Access Compliance Report Public Rights-of-Way (Curb Ramps)

Main Street: TROPIC_LN Cross Street: NEWPORT_AVE Location: S

ADA ID: RPRK220126105949 Ramp Type: Type 4 - Parallel Initial Pass/Fail: Fail Overall Compliance: No Severity Score: 2

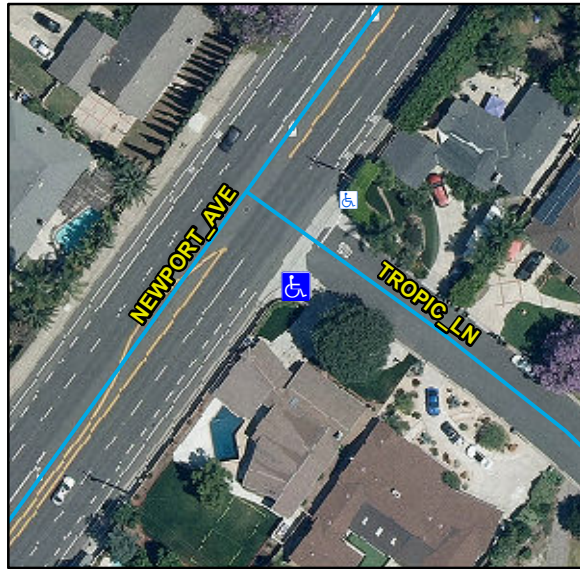
Compliance	Description	Data	Compliance	Description	Data
N/A	Ramp Length LT (in)	86	N/A	Ramp Length RT (in)	116
Yes	Ramp Width LT (in)	85	Yes	Ramp Width RT (in)	85
Yes	Ramp Run Slope LT (%)	2.7	Yes	Ramp Run Slope RT (%)	2.3
No	Ramp Cross Slope LT (%)	3.2	Yes	Ramp Cross Slope RT (%)	1.8
N/A	Landing Present	N/A	N/A	DWS Provided	N/A
N/A	Landing Length (in)	N/A	N/A	DWS Contrast	N/A
N/A	Landing Width (in)	N/A	N/A	DWS Length (in)	N/A
N/A	Landing Run Slope (%)	N/A	N/A	DWS Full Width	N/A
N/A	Landing Cross Slope (%)	N/A		DWS Offset Type	N/A
N/A	Landing Movement Obstructed?	N/A	N/A	DWS Offset Left (in)	N/A
	Landing Movement Type	N/A	N/A	DWS Offset Right (in)	N/A
N/A	Landing Shared	N/A			
N/A	Clear Space	Yes			
N/A	Clear Space To Crosswalk (in)	N/A			
N/A	Marked Crosswalk 1	No	N/A	Marked Crosswalk 2	No
	Crossing 1 Direction	NE		Crossing 2 Direction	NW
	Marked Crosswalk 1 Width (in)	N/A		Marked Crosswalk 2 Width (in)	N/A

Remove & Replace Curb Ramp With Two New Directional Ramps or Equivalent.

R304.5.3, STD 1115
